Ref: 80215013
Contact: John O'Grady

7 July 2017

MP 06_0250 MOD 9 – Modification to Residential Subdivision at Seaside Boulevard, Fern Bay

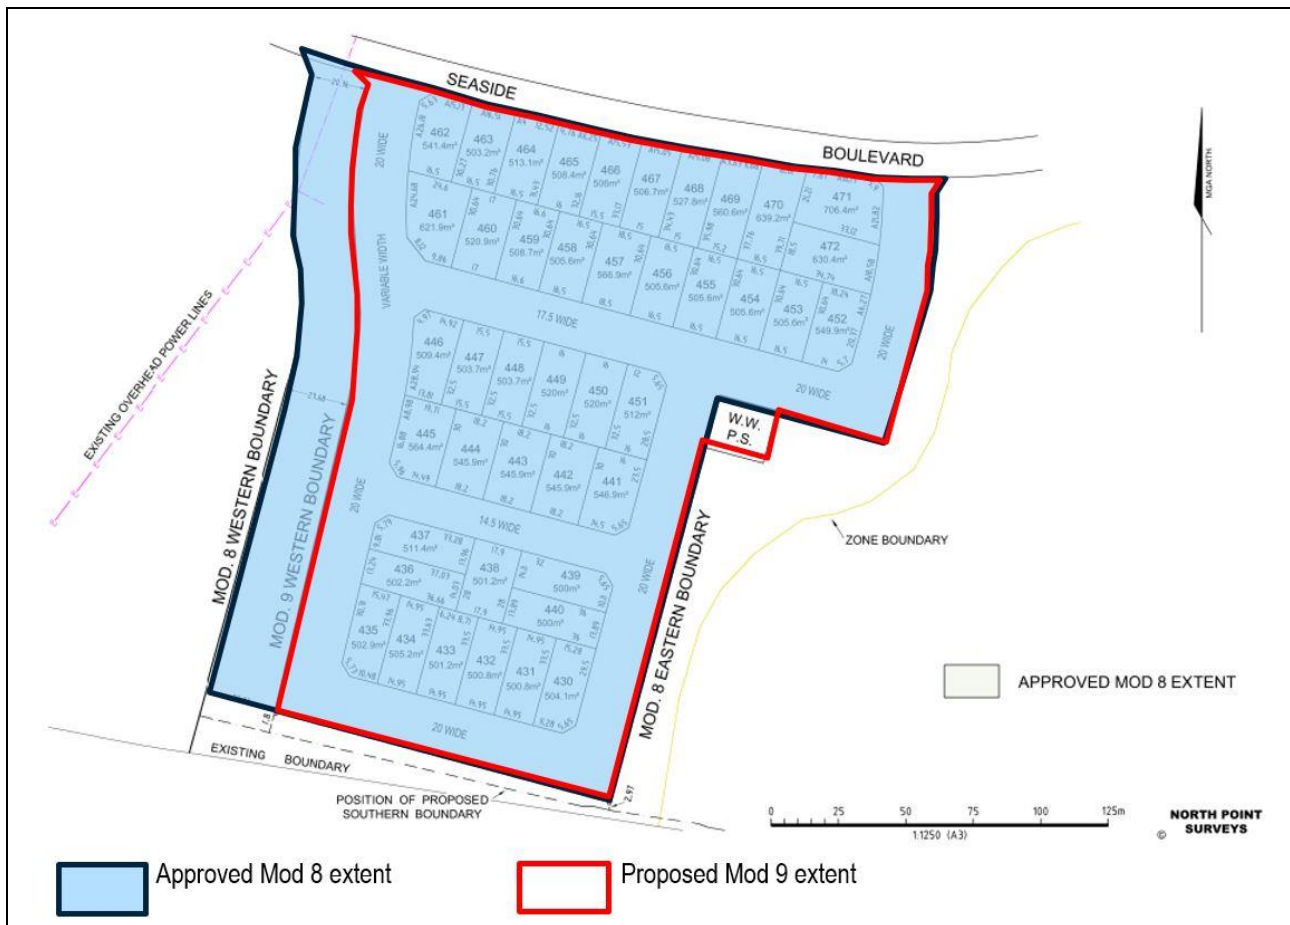
Port Stephens Council, the Office of Environment and Heritage (incl NPWS) and community members have raised concerns that the proposed modification includes a development footprint into the E2 Environmental Conservation zone.

Following further consideration of the concerns raised by agencies and the community, the applicant has reviewed the modification and made significant amendments to the proposed layout, including reducing the lot yield. The changes proposed as part of the modified layout restrict the development footprint to the residential zoned land so that there will be no ecological impacts. In particular, stages 18 and 19 have a reduced development footprint compared with that approved under modification 8. The proposed changes are, more importantly, a development reduction with a vegetation conservation outcome as identified below:

While the northern emergency connection to Nelson Bay Road runs through land zoned E2 – Environmental Conservation, this connection is approved and the land cleared under previous applications. The construction of the road/access does not involve additional clearing of indigenous vegetation within land that has been designated for conservation purposes.

Given that the 2nd access to Nelson Bay Road is proposed to be dedicated to emergency use only, there is another relevant consequence for retention of vegetation in that clearing for acceleration and deceleration lanes will no longer be required (subject to approval of the proposed modification).

The applicant has considered a number of development options, the agency responses and public submissions. The amended modification represents a more ecological sustainable development outcome as it no longer extends into E2 Environmental Conservation zone around stages 18 and 19 and in fact reduces the approved development extent. The proposed changes to stage 20 also significantly reduce the extent of required clearing albeit within the residentially zoned land. The proposal will also limit the extent of vegetation clearing associated with the northern access.
